Technical Service BULLETIN

A11712 FUJITSU TEN COMBO RADIO VOLUME CONTROL TOO SENSITIVE

'97 Camry

AUDIO
AU002-97

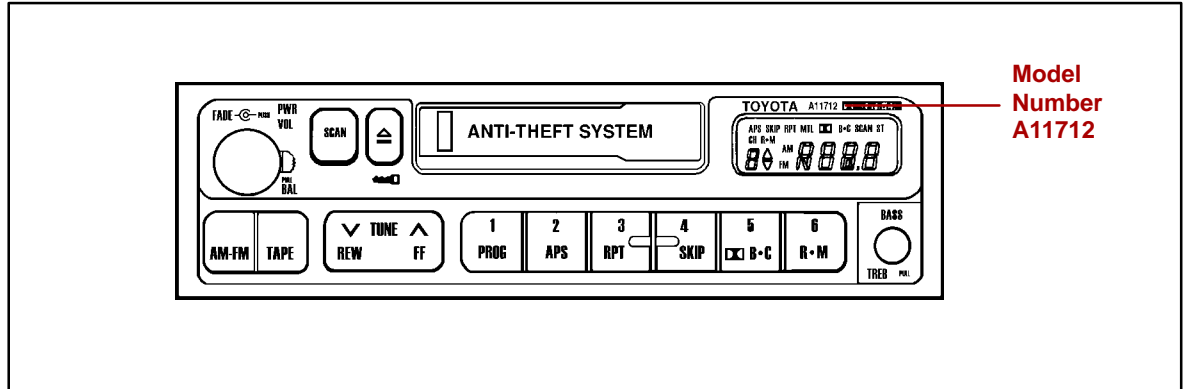
The A11712 Fujitsu Ten Premium Combo Radio for the 1997 Camry was changed to reduce volume control sensitivity. This condition is caused by the mismatching of the signal level between the radio and the amplifier. The output voltage of the radio was reduced to improve this condition.

Exchange the Fujitsu Ten A11712 Radio to correct this condition. Fujitsu Ten began shipping countermeasured exchange radios starting in October 1996. Countermeasured radios have a green line on the right side of the chassis. These radios will also be in a blue plastic bag.
